### REMARKS

Serial No.: 09/576,560  
Conf. No.: 1265

FIG. 10

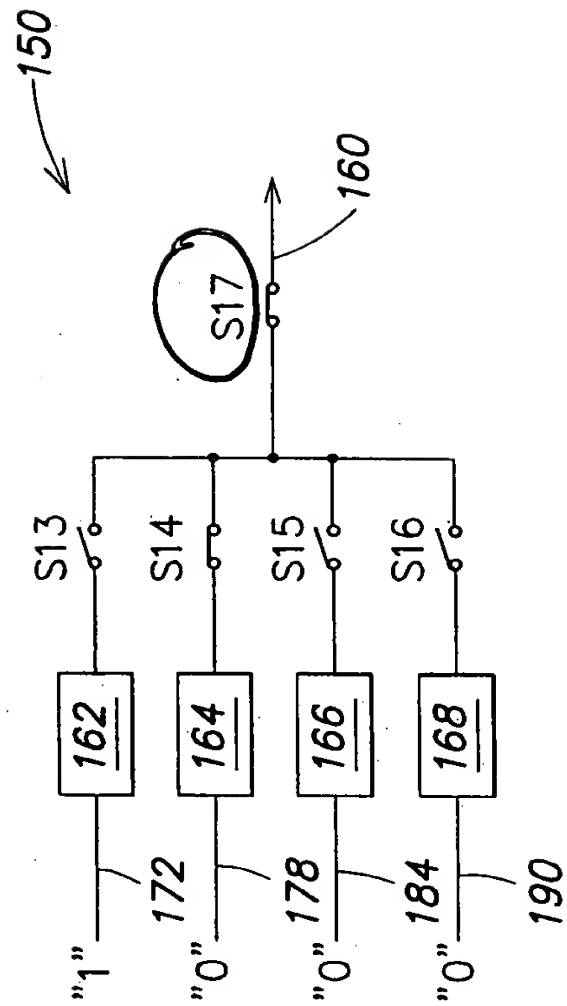
Formal drawings are submitted herewith. Applicant notes that in preparing the formal drawings, a correction has been made on Fig. 10, shown in a copy marked in red. Switch "S19" should have been Switch "S17," consistent with the labeling of that switch in other figures.
